**From:** Garrett Otto <[REDACTED]>  
**Sent:** Monday, December 9, 2019 7:20 PM  
**To:** Advisory Bodies  
**Cc:** Fukushima, Adam; Schwartz, Luke  
**Subject:** ATC - Froom Ranch Draft EIR  
**Attachments:** Pages from Draft EIR.pdf

Unfortunately I am unable to attend the meeting as I have another concurrent meeting to attend. After reviewing the Froom Ranch Draft EIR, I have the following suggestions for adjustments to the mitigation measures presented in the report.

**Partial List of Applicant Funded City Improvements to Transportation Network – Intersections 13, 14, 15, and 16**  
 [depicted improvements are not representative of final design plans, and may be constructed in conjunction with other projects in the area]

**FIGURE 3.13-3**

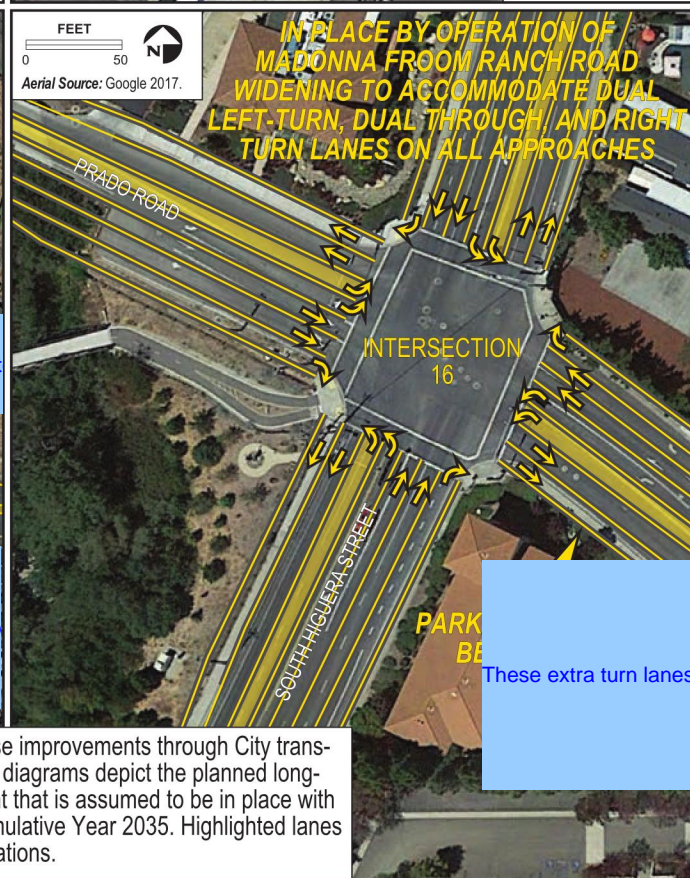
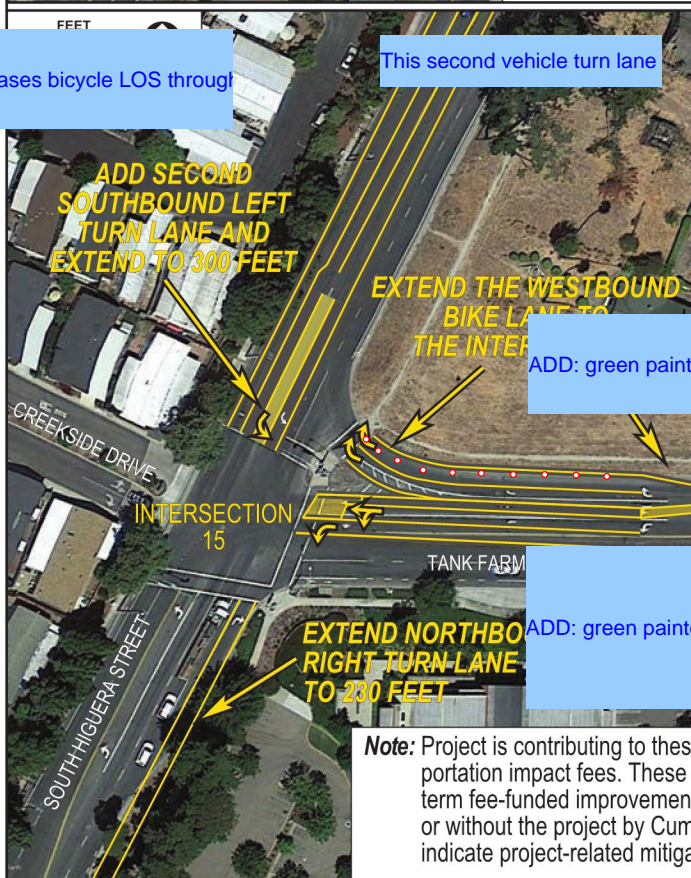
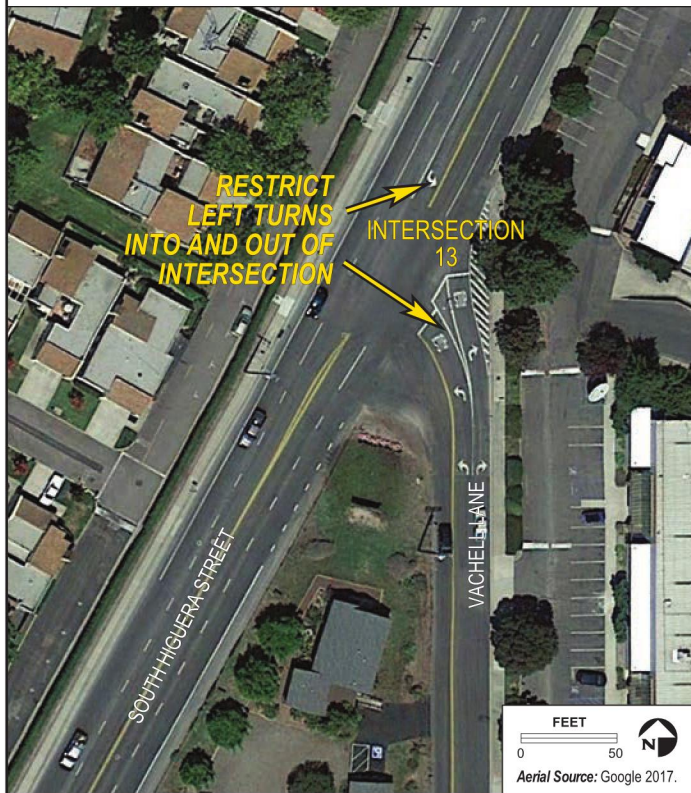
- Add a mitigation measure that requires dedicated coned-off bike and pedestrian lanes as part of any traffic control plans during construction efforts that impact access to bike lanes and/or sidewalks. Bicycles shall not be forced to merge into vehicle traffic during construction effort on LOVR. Use of "bike lane closed" and "sidewalk closed" methods as part traffic control plan shall only be allowed for short durations as a last resort if space cannot be accommodate in the vehicle travel lane.

- Proposed mitigation measures at S. Higuera and Prado to address Auto Queuing will significantly reduce the LOS for bicycle access at this intersection. These mitigation measure have potential to hard multimodal transportation options at this intersection. In order to add Class IV bike lanes on S. Higuera, a road diet is necessary. The new configuration of S. Higuera should only have one vehicle travel lane in each direction with a center turn lane. When you have two left hand turn lanes at this intersection will make it difficult to add in a Class IV bike lane along S. Higuera. Additionally 2 left turn lanes makes it much more difficult and stressful to merge into the left turn pocket by bike. Increasing the length of a single left hand turn lane should be used instead of dual left turn lanes. I would argue that vehicle queuing is acceptable impact compared to compromising multimodal access at this intersection and corridor. These mitigation should be revised to be consistent with the proposed Class IV bike route as part of the ATP. The mitigations should be revised such that improvements at Prado and S. Higuera shall be designed as a bicycle protected intersection similar and consistent to the instersection designed a Dalido and Madonna.

- Proposed mitigation at Tank Farm and S. Higuera indicate adding a second left hand turn lane to address Auto queuing. For similar reasons to the intersection at Prado, this mitigation will decrease bicycle LOS by reducing street space that could be allocated for Class IV bikeways. The mitigation should be altered to simply extend the left turn lane. In addition all bike lanes approaching and passing through the intersections shall be extended and painted green for higher visibility of cyclist traveling through the intersection. The right hand yield turn lane turning northbound from Tank Farm to S. Higuera should the bike lane extended through the intersection with protective post to provide extra level of protection for cyclist and reduce the turn radius of vehicles. The crosswalk should be restriped with high visibility paint and a flashing beacon to warn traffic of pedestrians in the crosswalk since it is otherwise "uncontrolled".

- Traffic models indicate potential volume increase on S. Higuera due to the project. A mitigation measure should be added to pay fair share or build Class IV infrastructure along S. Higuera.

I wish I had more time to review and provide additional comments. I have attached a page out of the Draft EIR which I marked up with the suggests I described above to help clarify. My comments are in blue.
